W3P87-0151

ATTACHMENT B

REVISED NPF-38-51 CHANGE REQUEST

FIGURE 6.2-1
ORGANIZATION FOR MANAGEMENT AND TECHNICAL SUPPORT

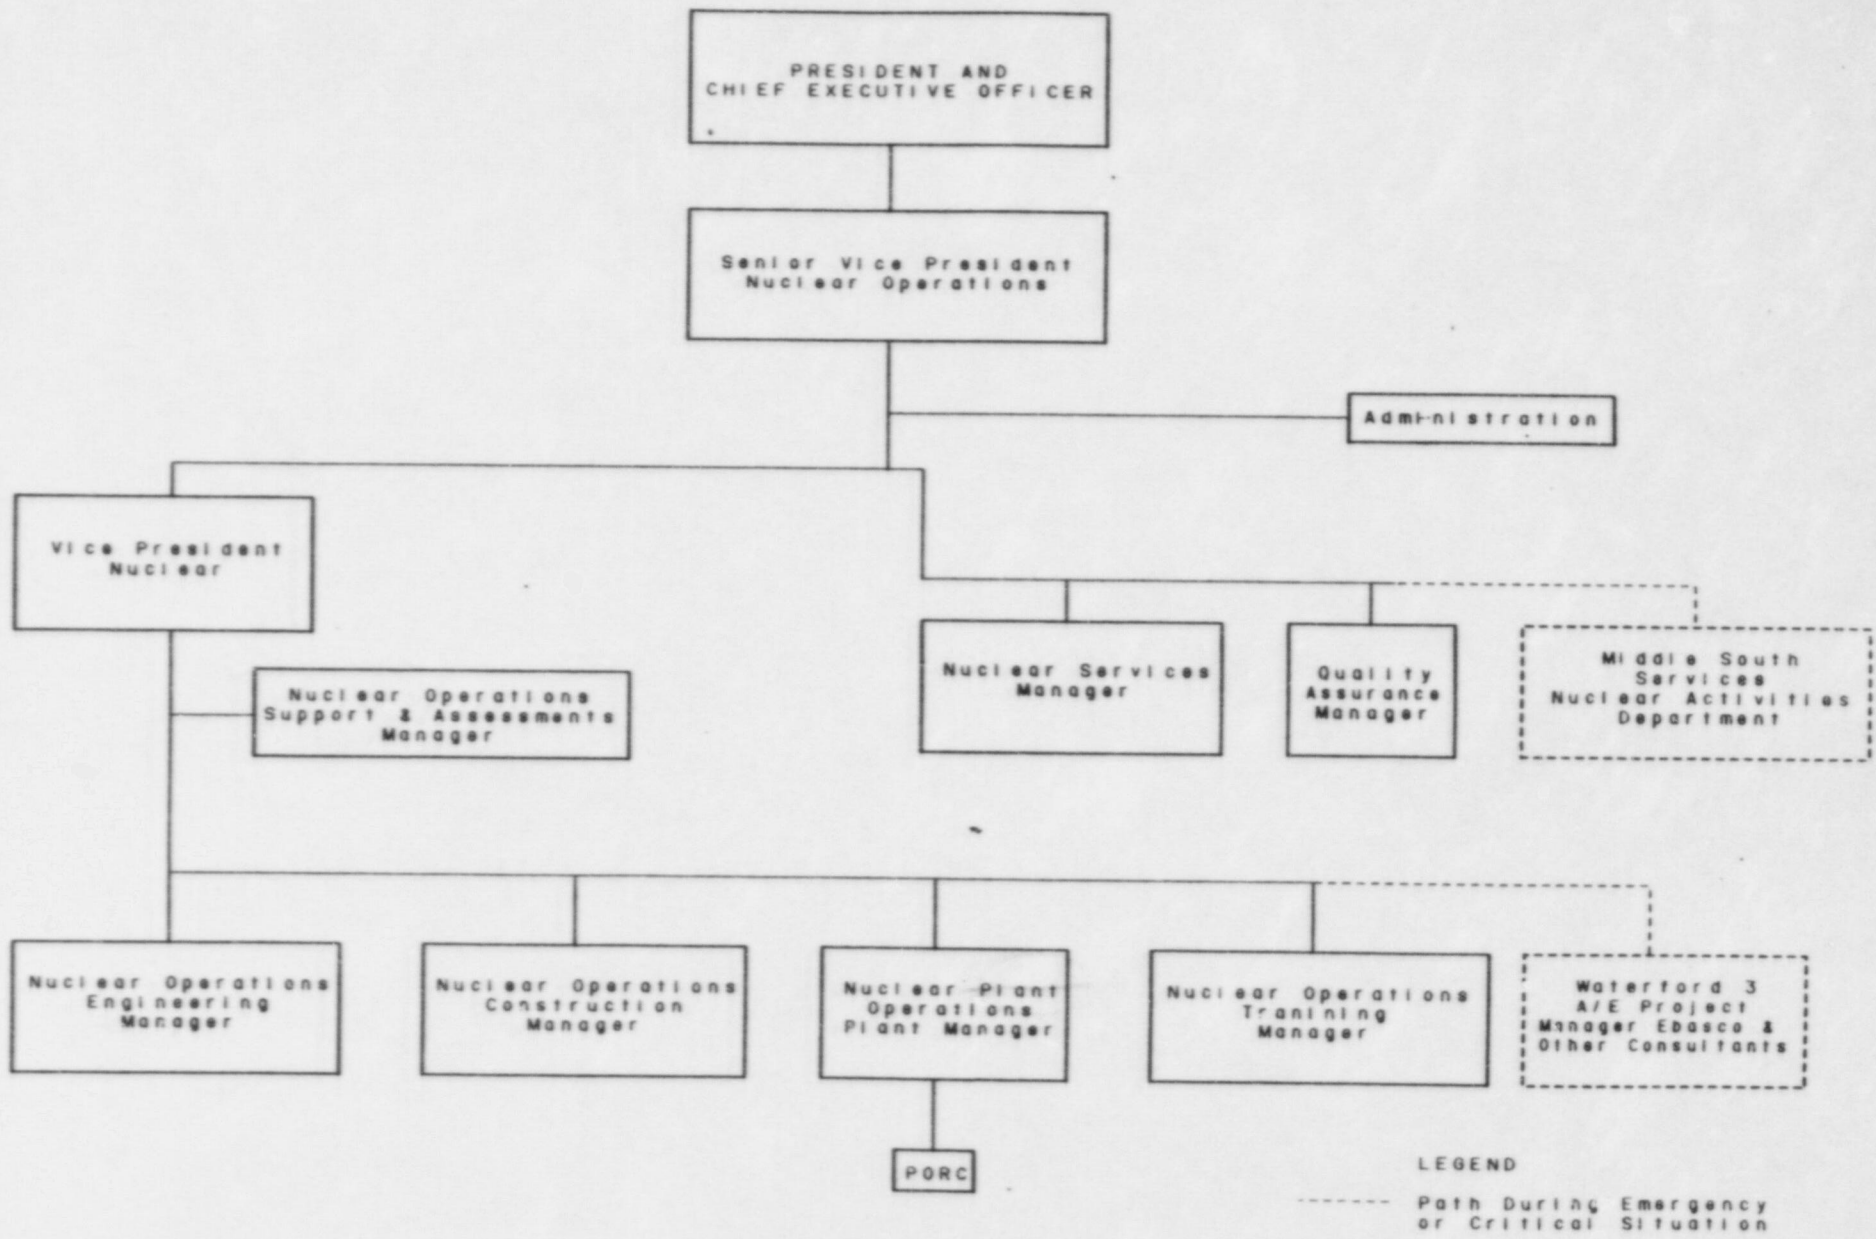
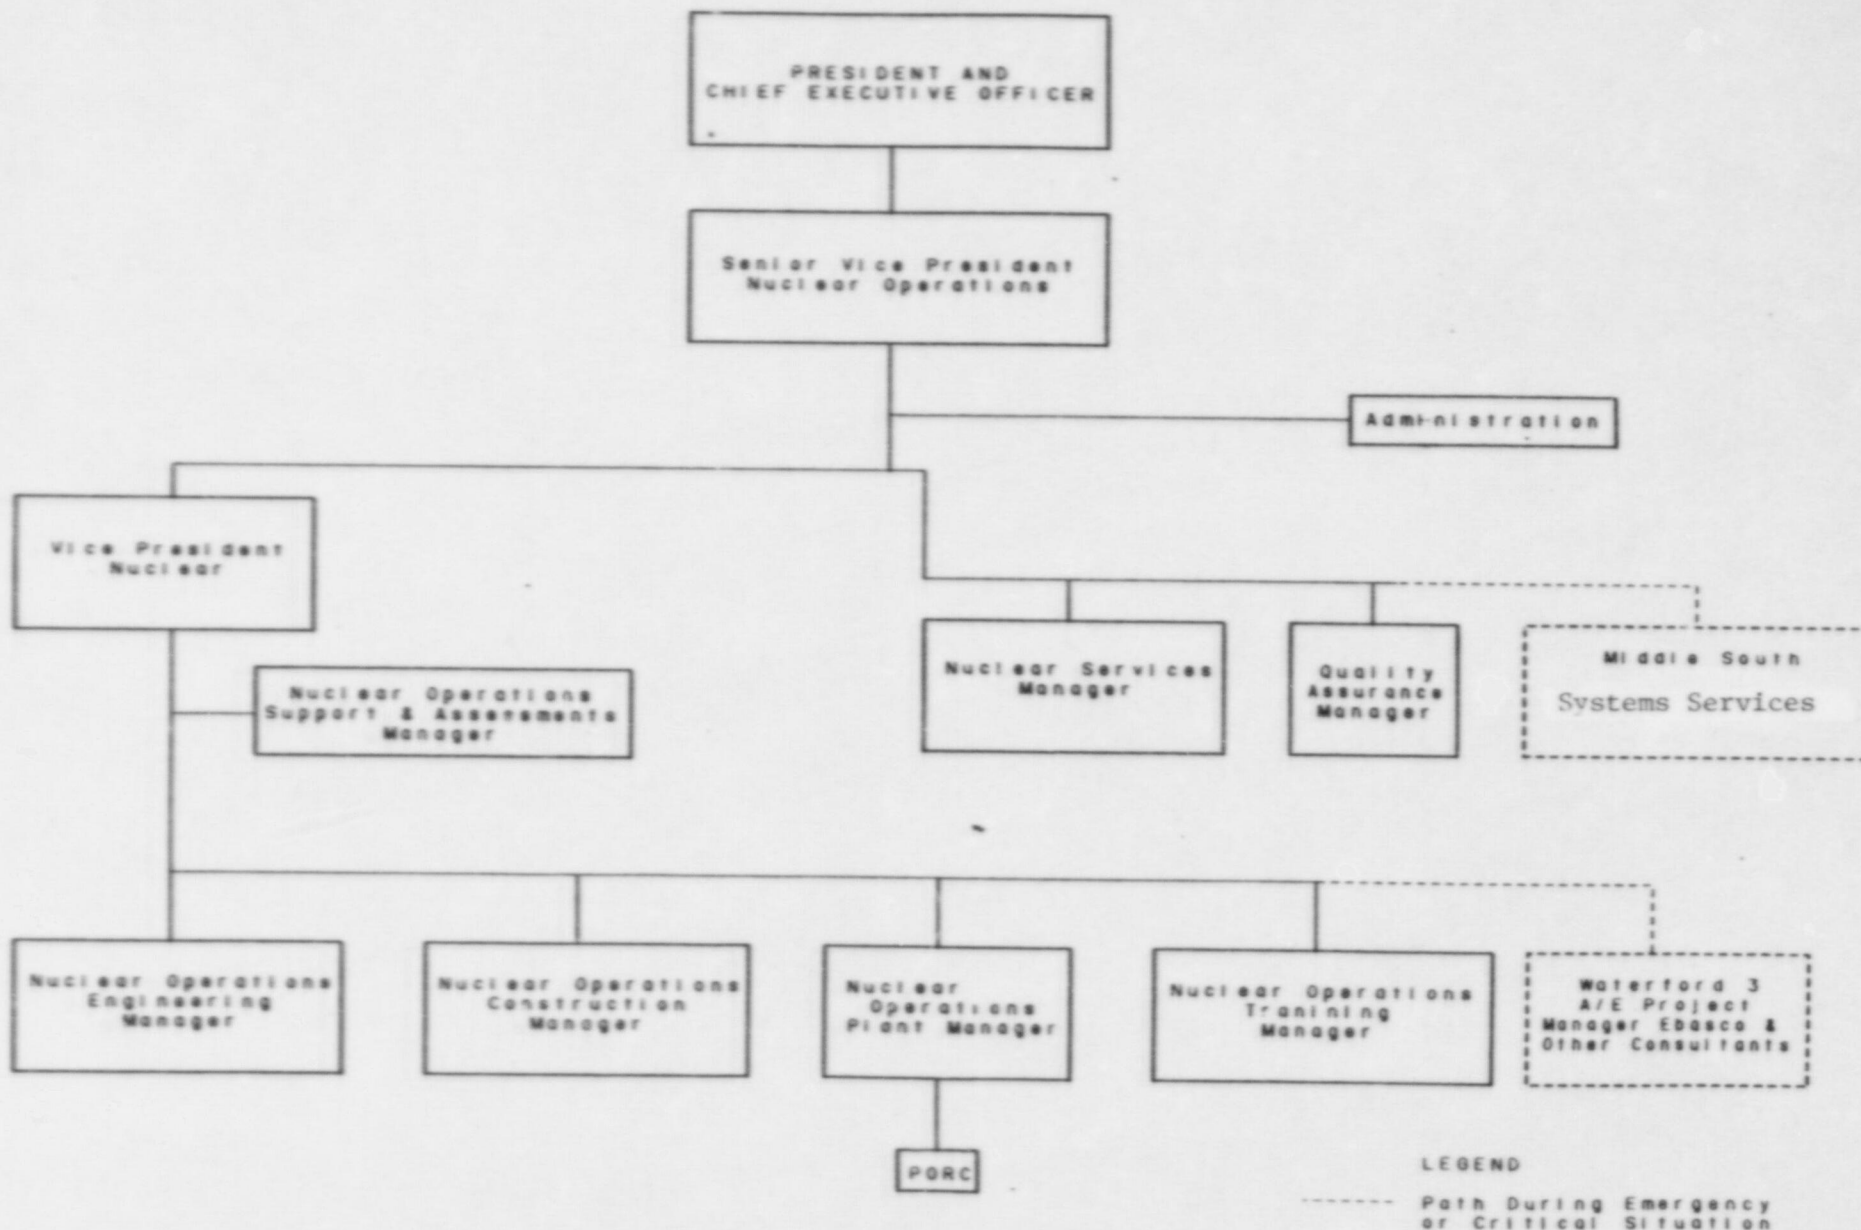
~~OFFSITE~~ MANAGEMENT AND TECHNICAL SUPPORT

6.2.1 The ~~offsite~~ organization for unit management and technical support shall be as shown in Figure 6.2-1.

FIGURE # 2-2
PLANT OPERATIONS ORGANIZATION

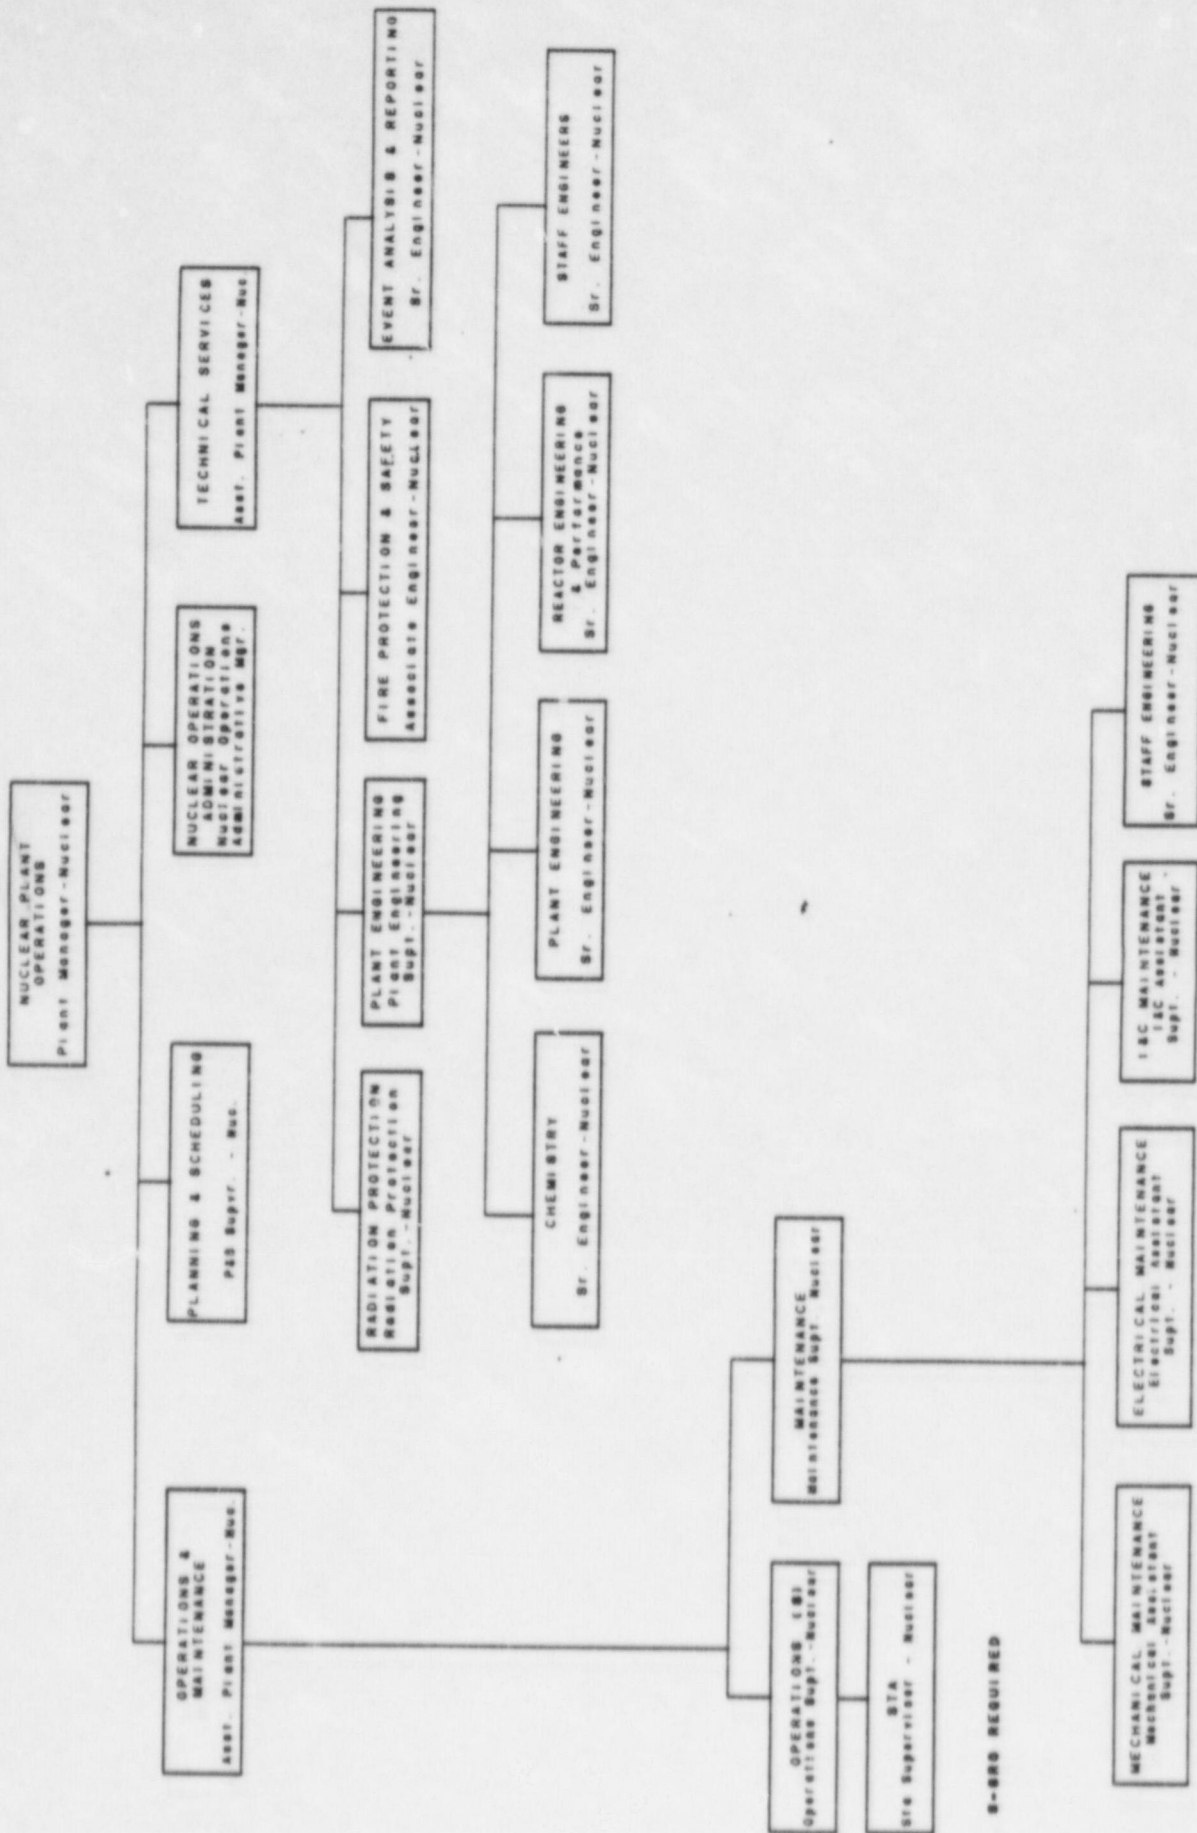
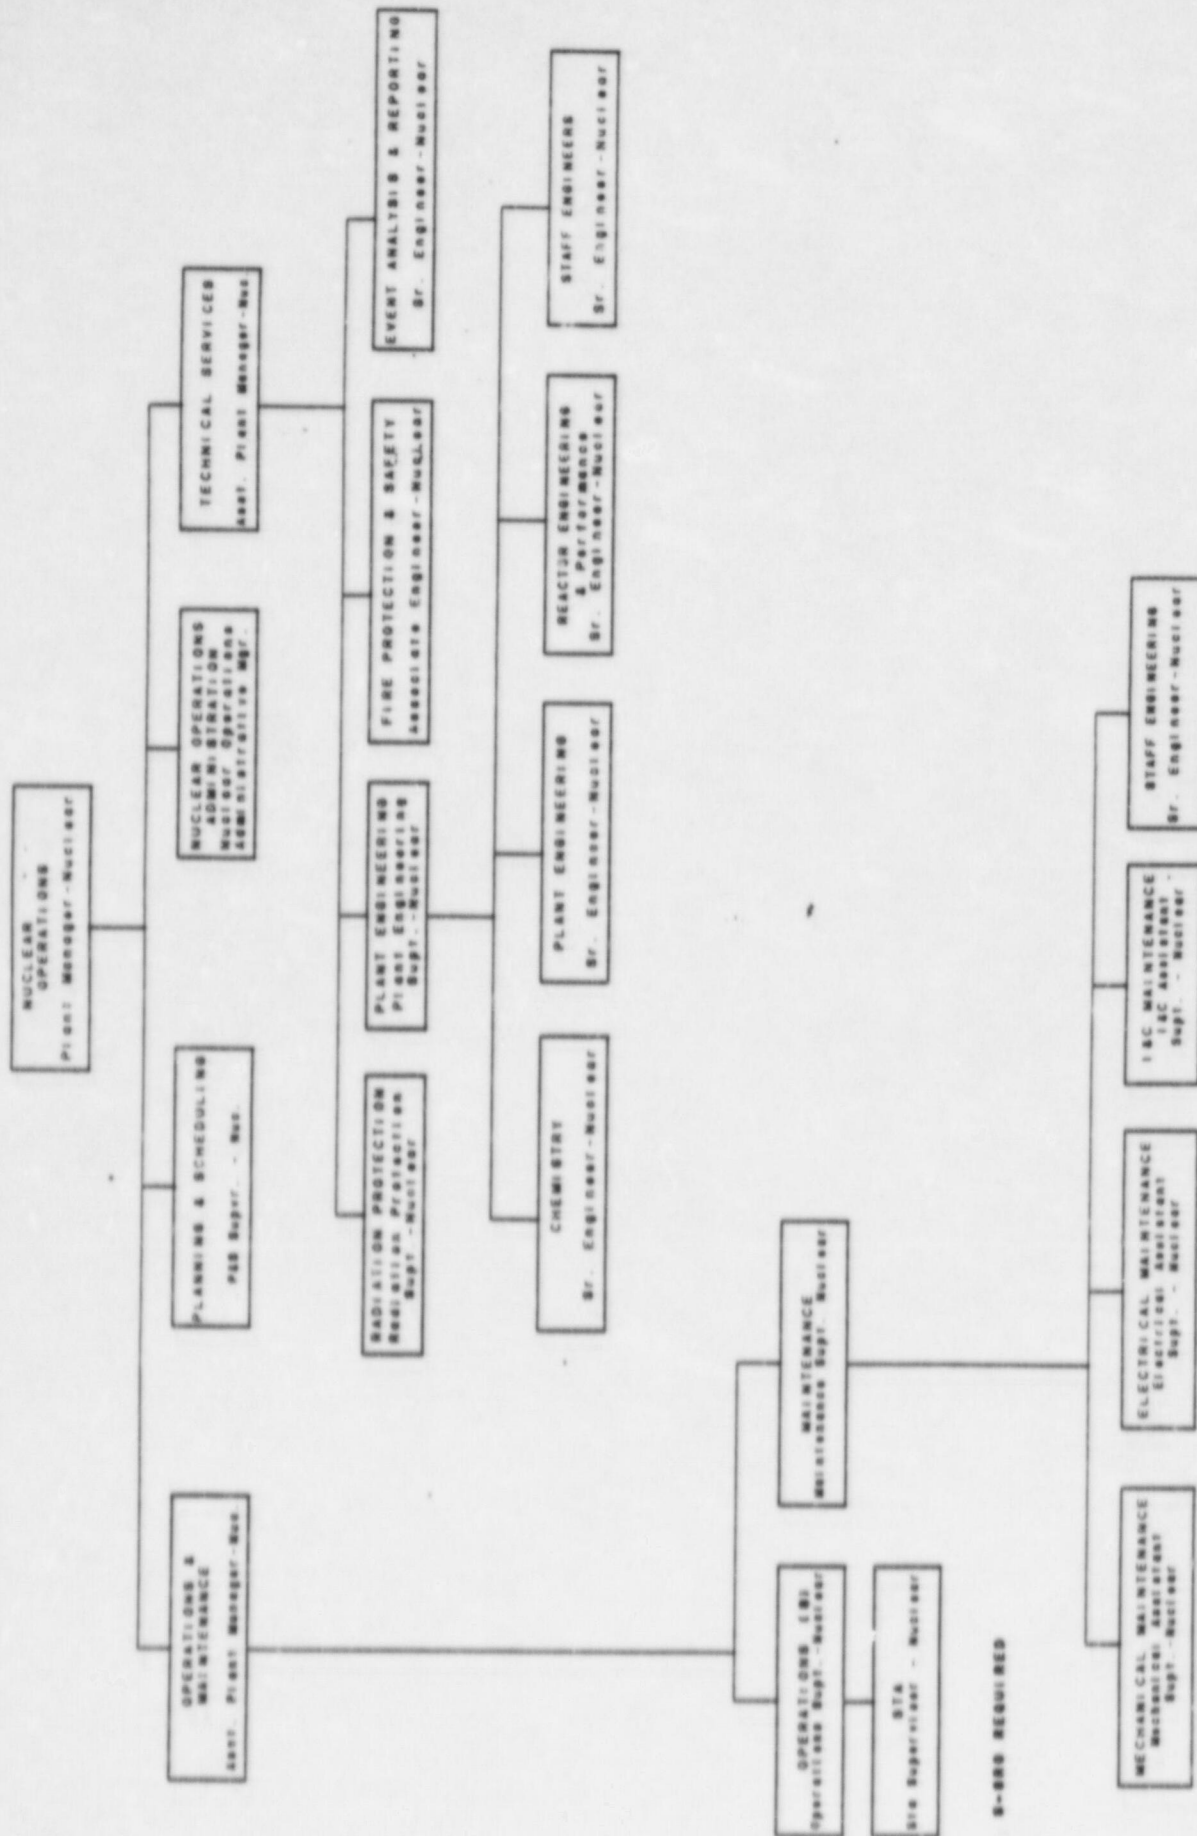
6.2.2 The unit organization shall be as shown in Figure 6.2-2 and:
